SAXTON NUCLEAR EXPERIMENTAL CORPORATION

DOCKET NO. 50-146  
LICENSE DPR-4

Amendment No. 1 to Change Request No. 32

## SAXTON CORE III LOSS-OF-COOLANT ACCIDENT RE-EVALUATION

Figure 1

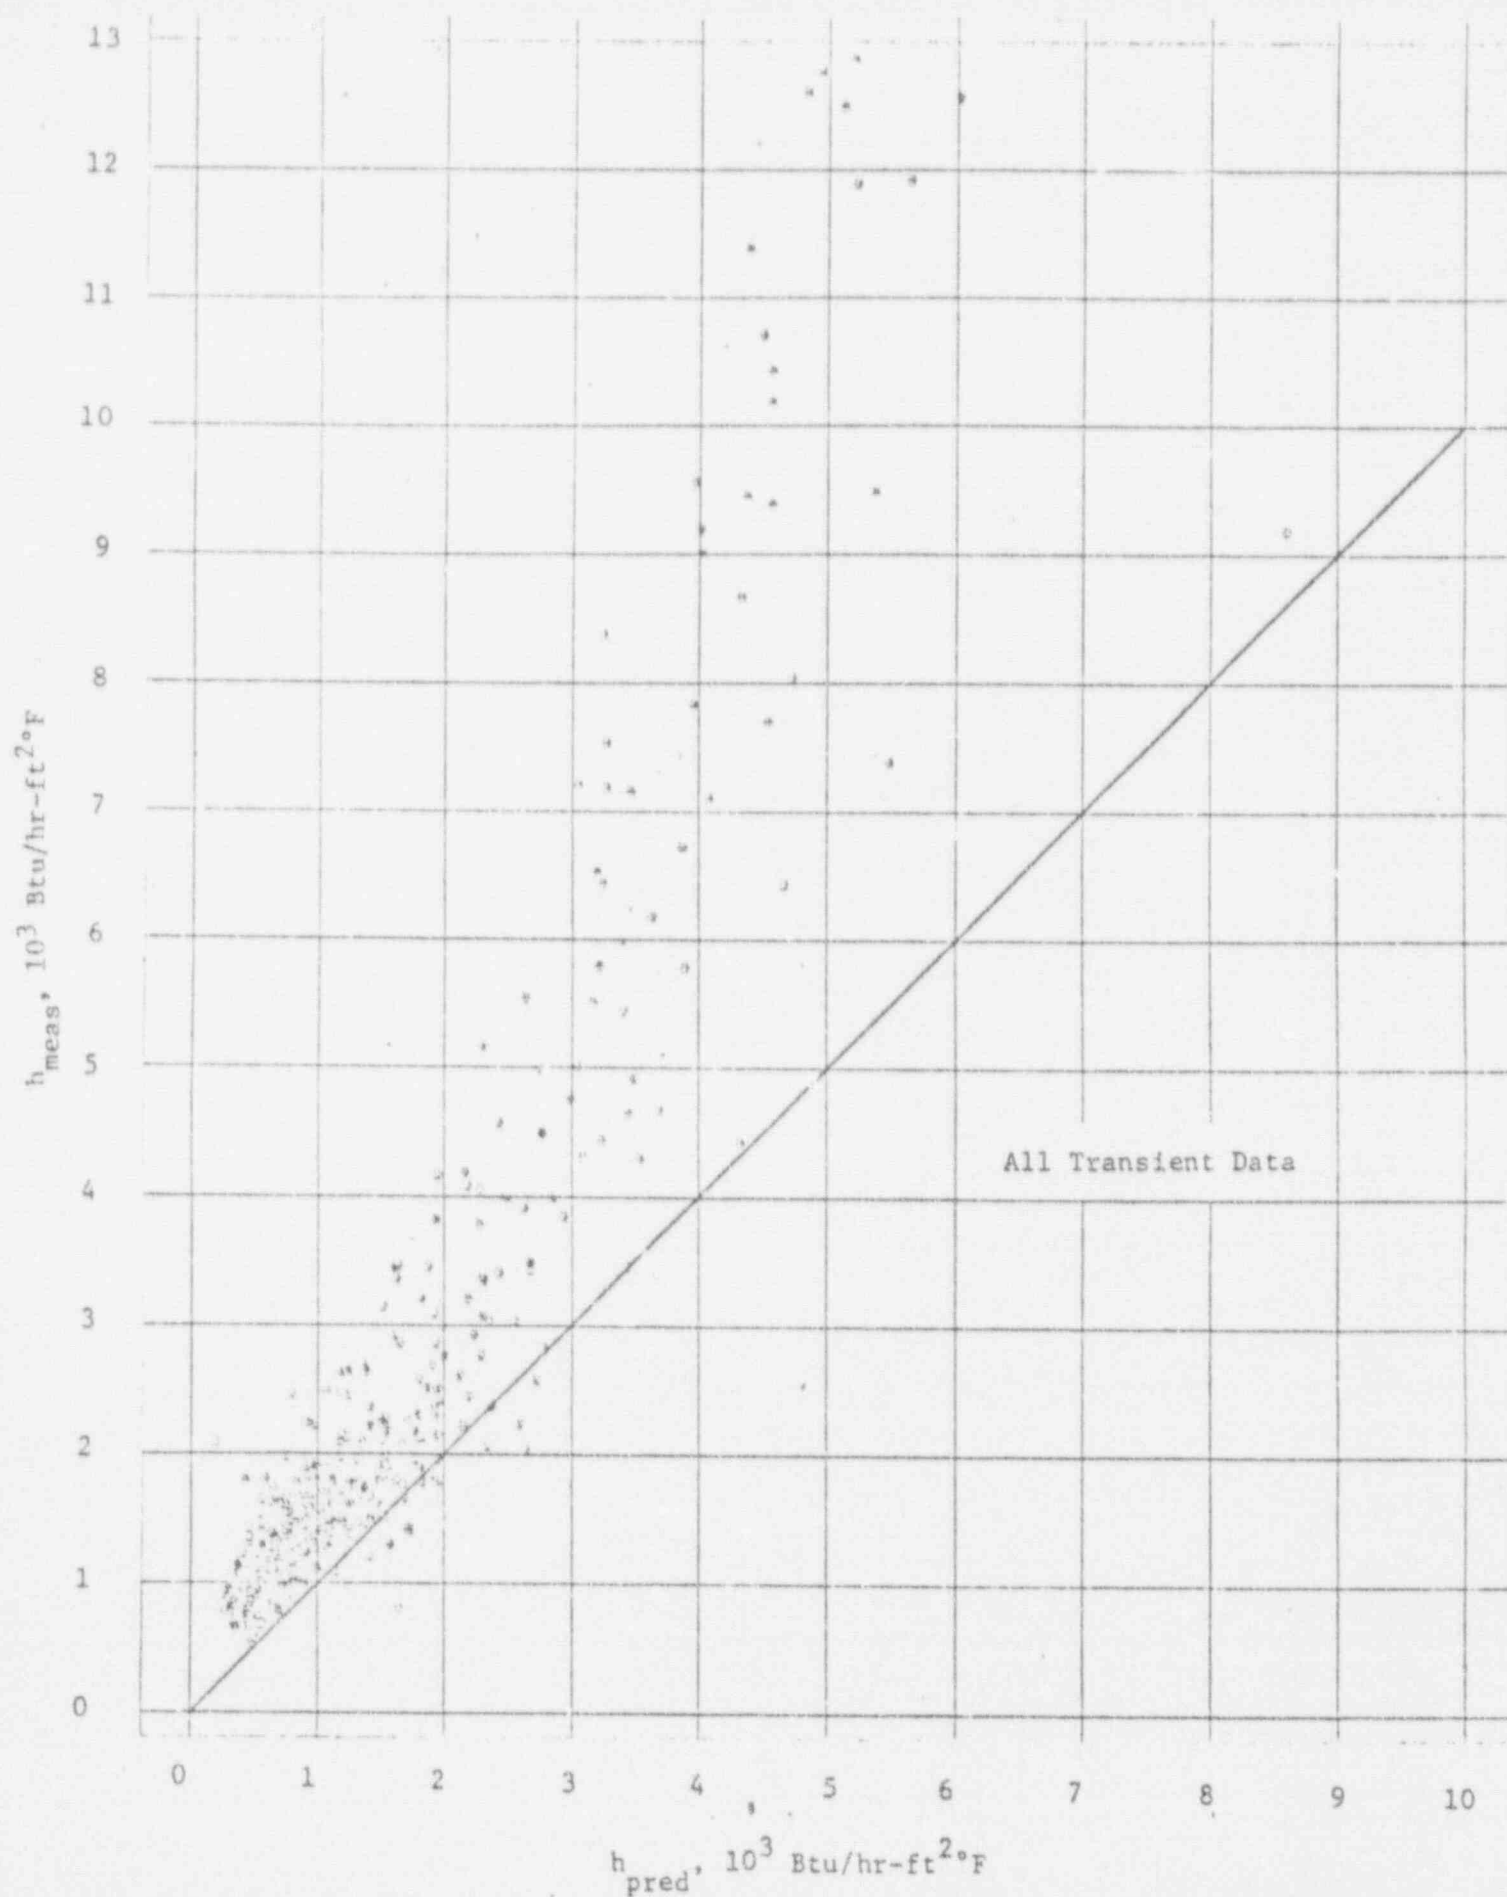
2. The heat transfer models in the LOCTA-R2 core thermal analysis code are the same as those described in Section 4 of the report "Saxton Loss-of-Coolant Accident Prevention and Protection" except that stable film boiling immediately following the occurrence of DNB at 0.5 seconds, is no longer assumed. Instead, post DNB heat transfer coefficients during the transition and stable film boiling phases of blowdown are now calculated using an empirical correlation developed by Westinghouse, from steady state heat transfer data. It has been compared with experimentally determined transient data recently obtained as part of the Westinghouse Flashing Heat Transfer research and development program. (1)

A comparison of the measured heat transfer coefficients obtained from the transient blowdown data and the coefficients calculated with the empirical correlation is presented in Figure 1. It is concluded that the heat transfer coefficients during the transition and stable film boiling phases of blowdown can be conservatively estimated by the recently developed Westinghouse empirical correlation.

FIGURE 2

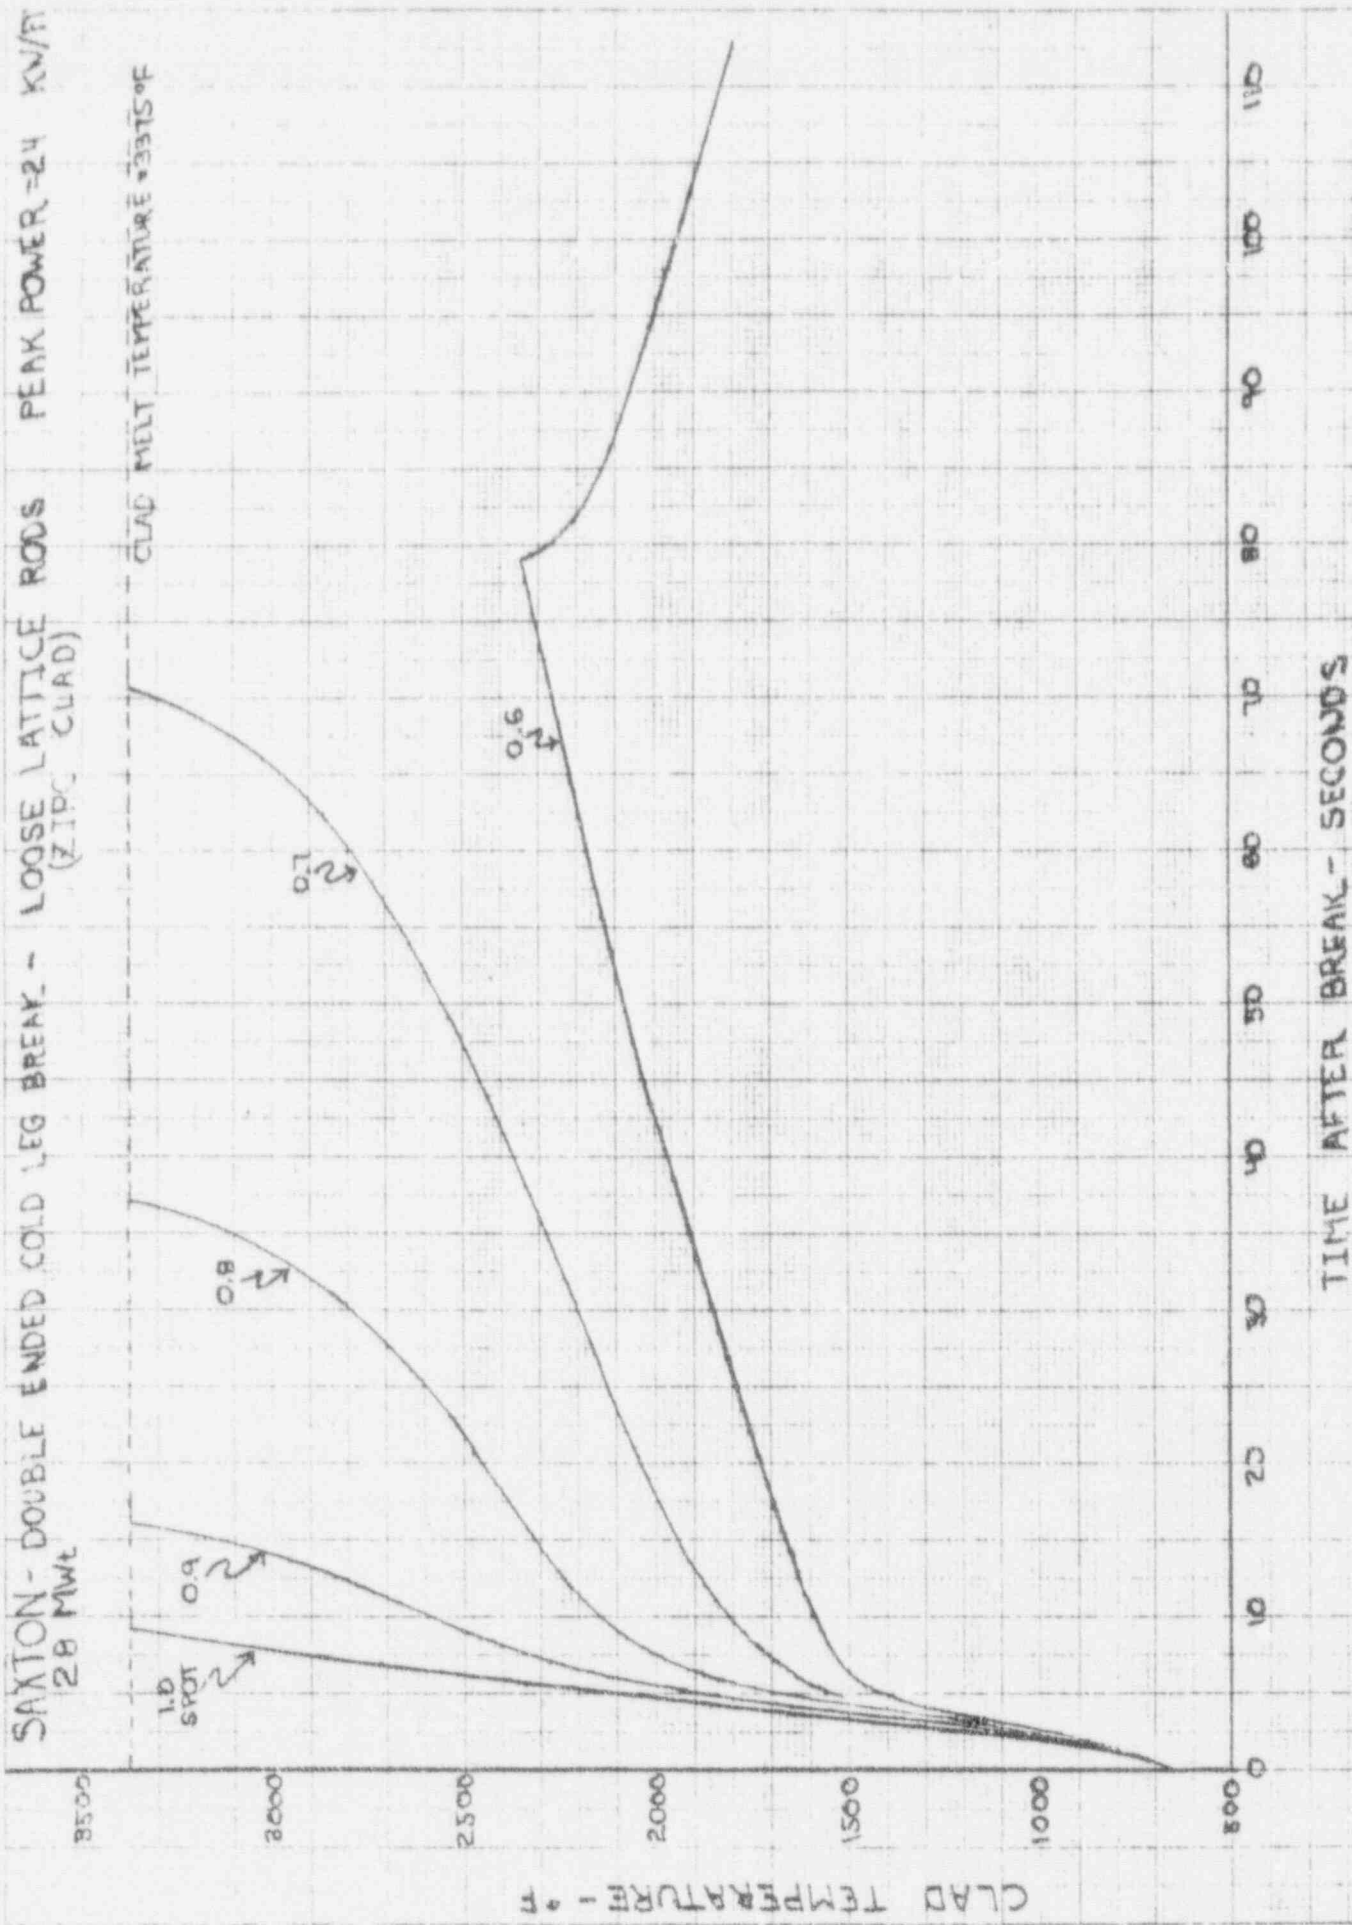
Figures 2 through 4 show the clad temperature transients for the high power density Zircaloy clad rods located in the Loose-Lattice assemblies. Presented in these figures are the clad temperature transients for rods operating at various fraction of the design peak linear heat rate of 24 kw/ft. Figures 5 through 10 show the clad temperature transients for the Zircaloy and stainless steel clad rods located in the load follow assemblies. The design peak linear heat rate in these assemblies is 19.9 kw/ft.

FIGURE 9

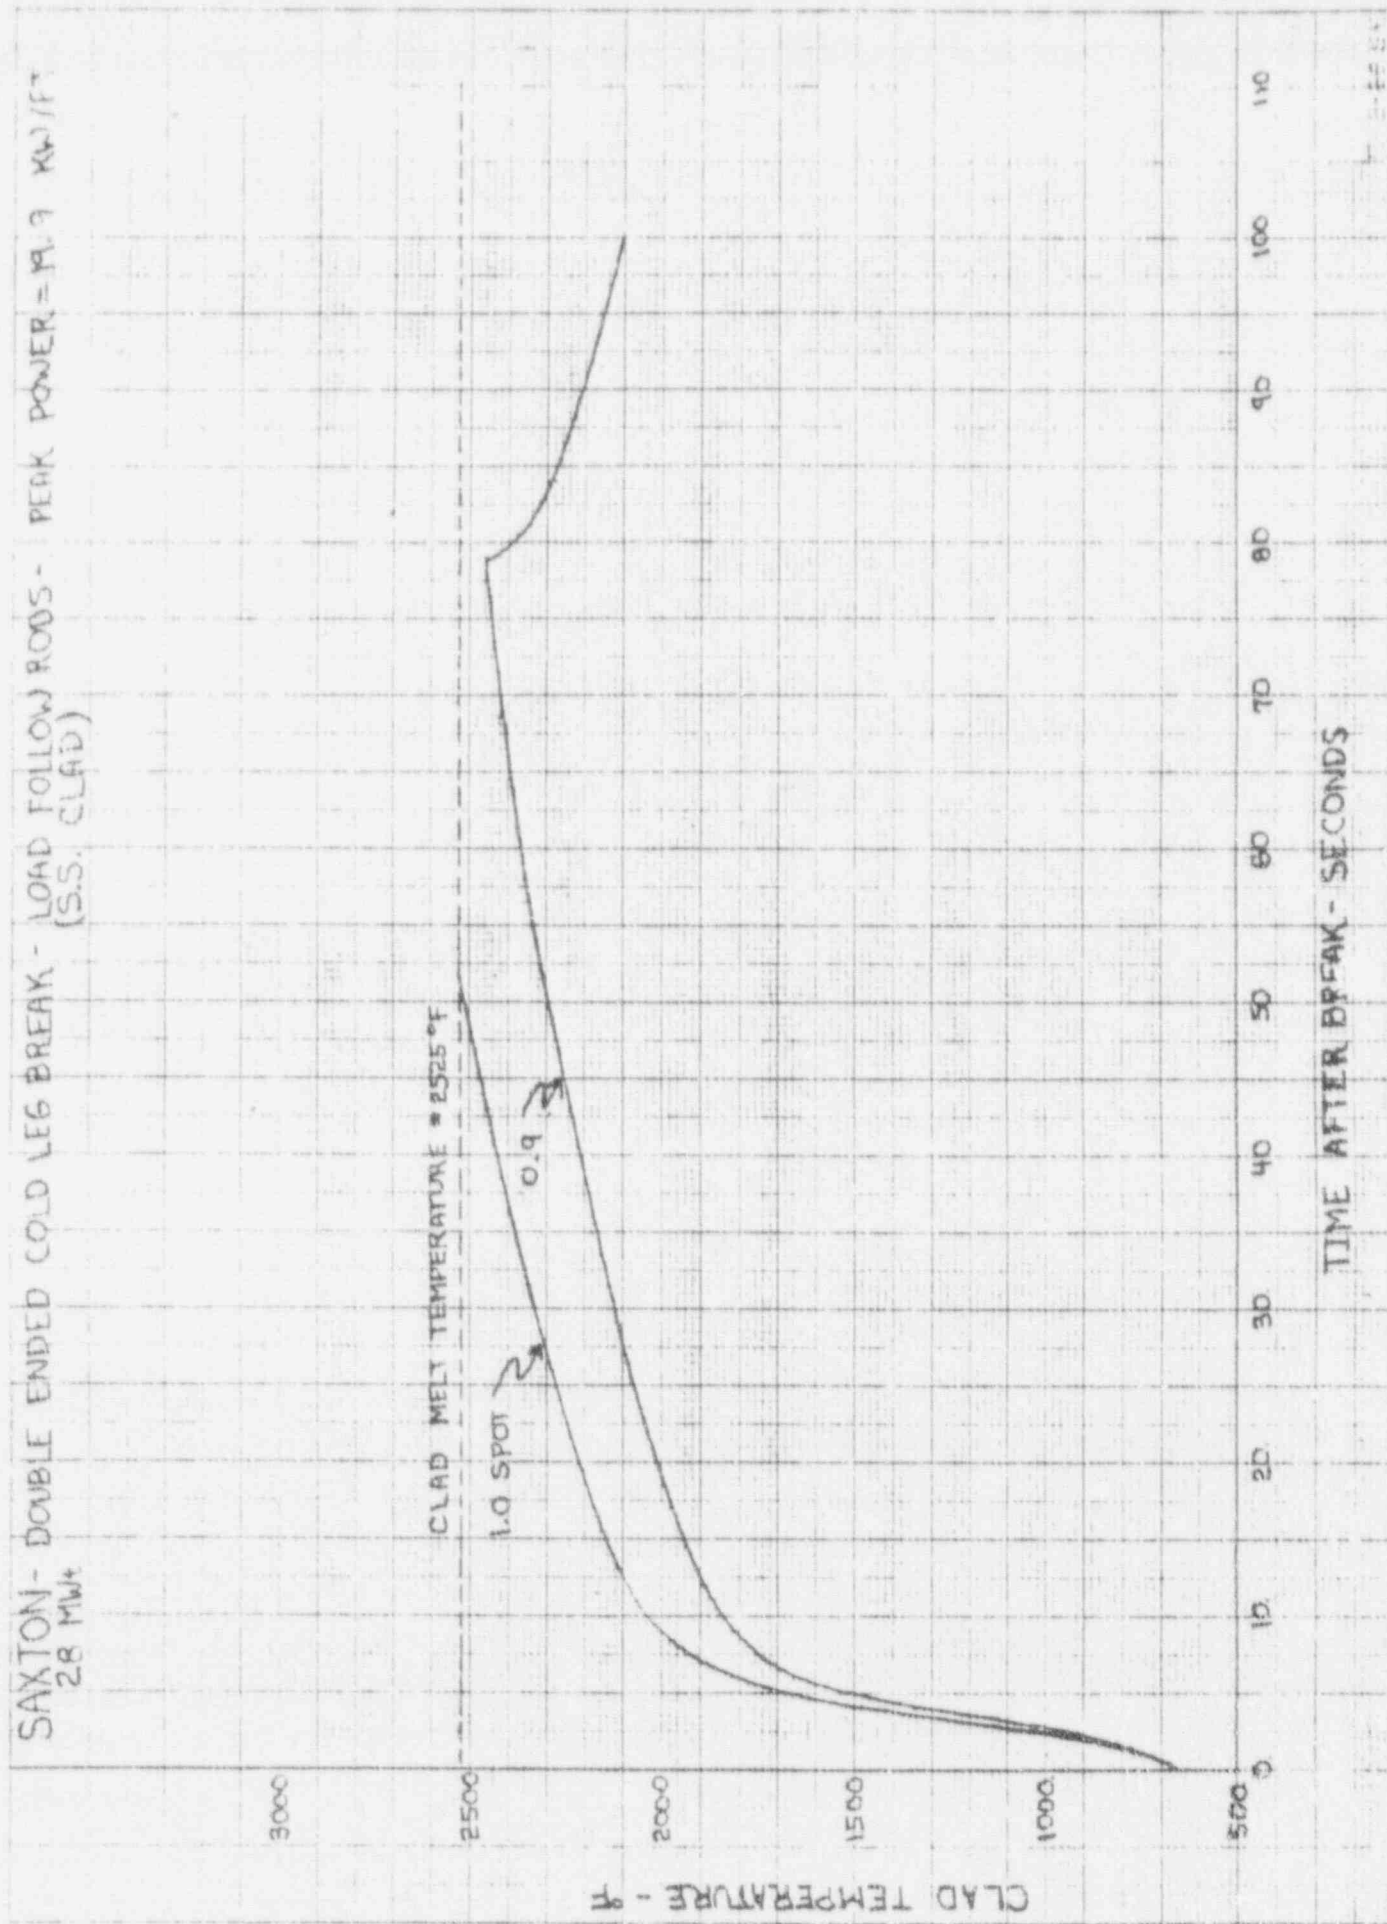
Since the stainless steel clad rods located on the core periphery are operating at approximately 33.1% of the peak linear heat rate of 24 kw/ft, the peak clad temperatures exhibited by these rods would be much lower than those presented in Figures 8 through 10. The clad melt is limited to 8.9% for the double-ended break with no melt occurring for the surge line break. The loss-of-flow analysis re-evaluation gives a negligible change in heat flux response and minimum DNB ratio during the accident.
